**Office of Planning and
Community Development**
700 5th Avenue, Suite 2000
PO Box 34019
Seattle, WA 98124-4019

Project Description

This was the Seattle Design Commission's (SDC) second review of the proposed concept design. Following the presentation, SDC review and deliberation, the SDC voted, 7-0 in favor of the schematic design, with several recommendations.

Schematic Design

Figure 1: Section of loading area

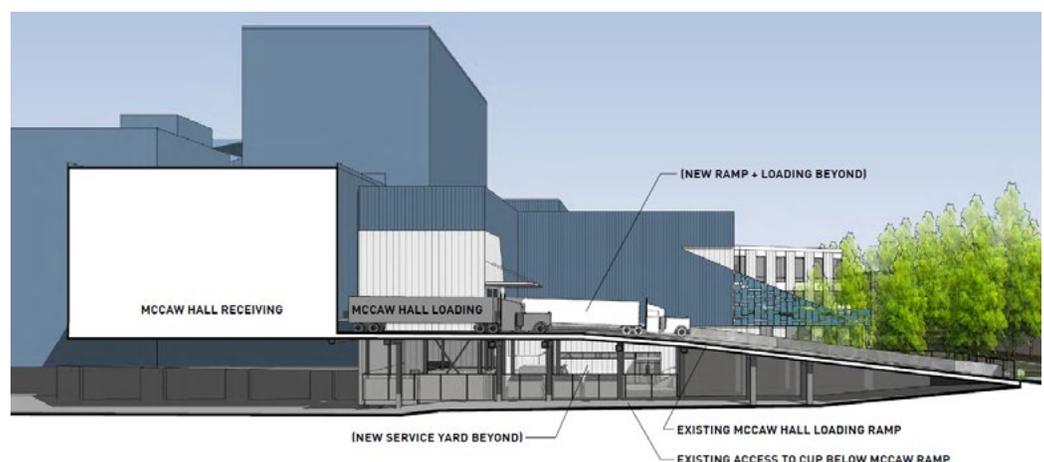
Matthew Somerton presented the updated project designs that address the SDC conditions from the previous meeting and the overall project and program development. As a result of the last meeting and a separate subcommittee meeting on March 24th, 2016, the loading service for McCaw Hall and the greater Seattle Center at the intersection of Republican St and 4th Ave N will remain at its existing location even as Memorial Stadium is redeveloped. Loading services for the new facility will be located adjacent to existing loading services along 4th Ave N. The loading area will be aesthetically enhanced through the use of landscape materials and fencing, which will provide a safety barrier without fully screening the loading area. See *figures 1 and 2 for more detail.*

Figure 3: Proposed scrim facade update

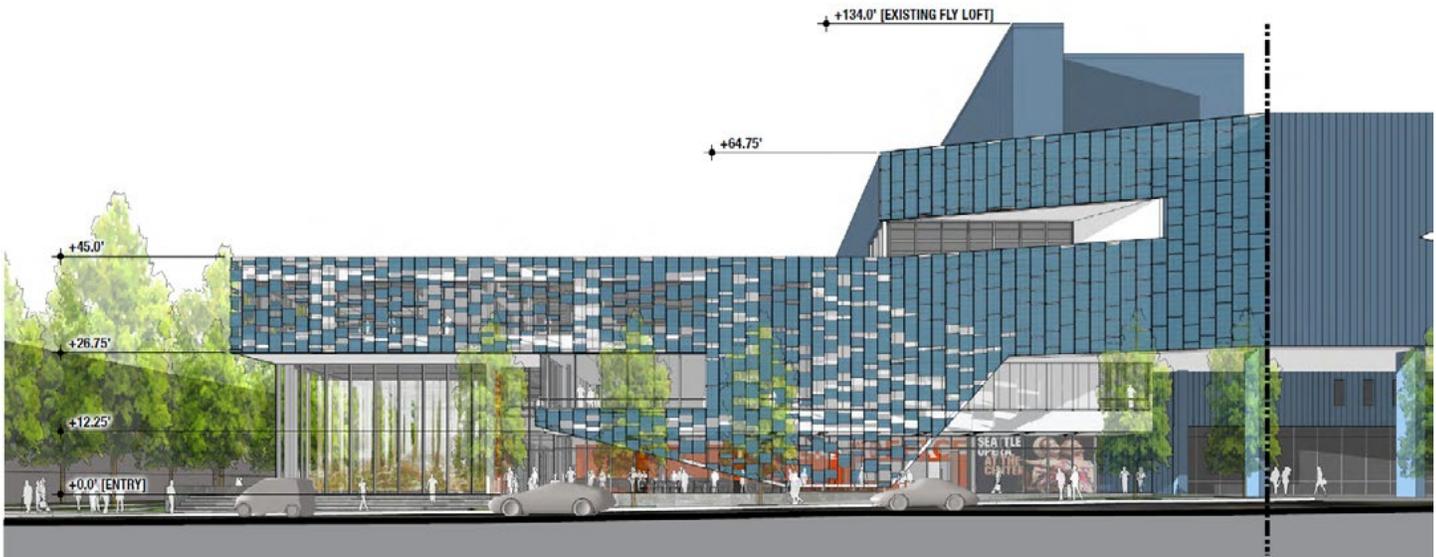
The SDC agrees the updated scrim façade design and its increased perforations provides a greater level of transparency at key points along the Mercer St. and 4th Ave. N façade. The SDC recommended the design team continue to refine both the gradient and transparency of the scrim design as the project moves forward. Commissioners also recommended the project team consider implementing the scrim design in a way other than hanging panels on a cable.

1. Consider the location and design of the bus loading zone along 4th Ave N
2. Continue to angle the scrim as it hits the ground plane along 4th Ave N in order to provide greater transparency into the costume shop
3. Continue exploring material, signage, landscape, and seating along 4th Ave N and Mercer St to reduce barriers to activity
4. Consider accessibility and length when designating pathways within the surrounding landscape
5. Continue to modify the panel gradient of the scrim in key areas in order to provide a greater level of transparency
